## Mastspielraum - neue Regel 6.103, 6.104

## **IDA Technical Committee Report October 2015**

### **Change of Class Rule 6.103**

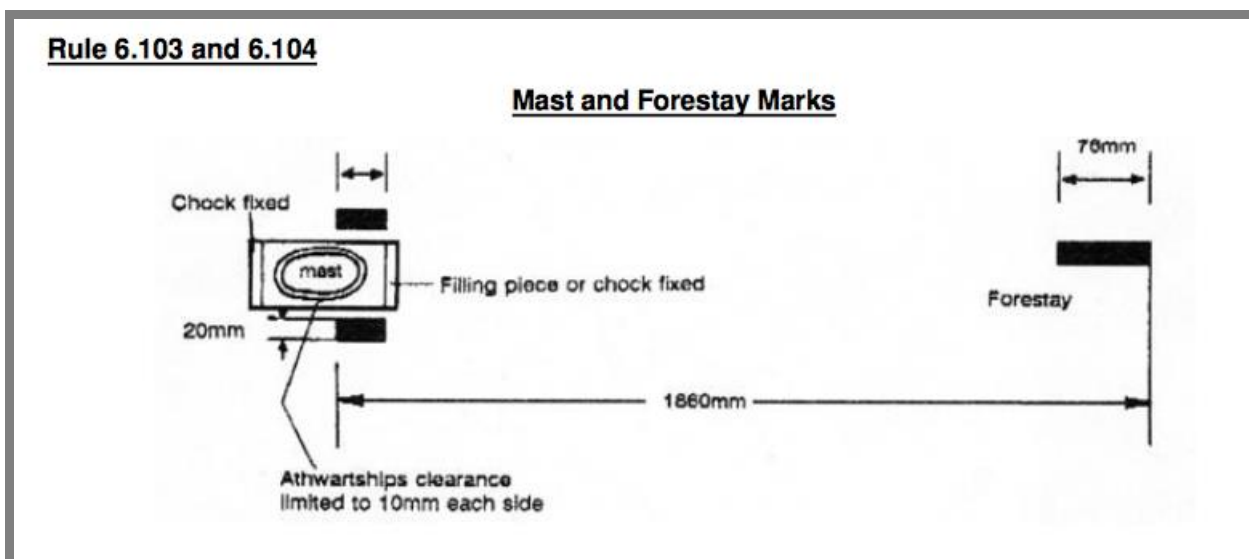
Ab 1. März 2016 tritt eine neue Regel in Kraft, die den Mastspielraum in Deckshöhe begrenzt (Regel 6.103 & 6.104).

Zwei Markierungen (50 mm x 20 mm) müssen beidseitig seitwärts der Decksdurchführung angebracht werden. Die Vorderseite des Masts darf sich nur innerhalb des so festgelegten Spielraums bewegen. Seitwärts darf sich der Mast nicht mehr als 10 mm bewegen lassen

Um dies sicherzustellen, sind zwingend zwei fixe Keile oder Bolzen („Filling pieces or chock fixed“) anzubringen. Die Begrenzung des Mastspielraumes durch den Mastcontroller alleine ist nicht ausreichend.

### Change of Class Rule 6.103

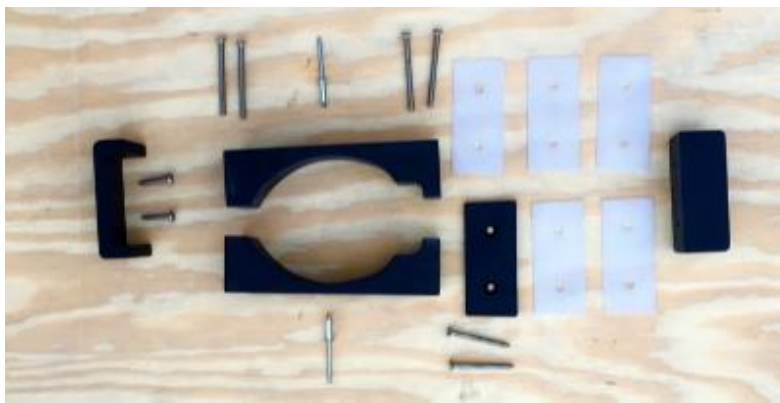
Delegates were reminded that Class Rule 6.103, requiring the mast movement at deck level to be blocked off, shall apply to all Dragons from 1st of March 2016.

*“Mast movement at Deck level – the proposal of the Technical Committee is to restrict the mast movement at deck level by using chocks or screws to limit fore and aft movement as there are concerns that some sailors may not be adhering the present rule of fore and aft mast movement.”*

The Technical Committee is clear that boats who don't have chocks in place as required will be disqualified. Existing boats will have until March 2016 to make the necessary changes while new boats have to comply from March 2015.
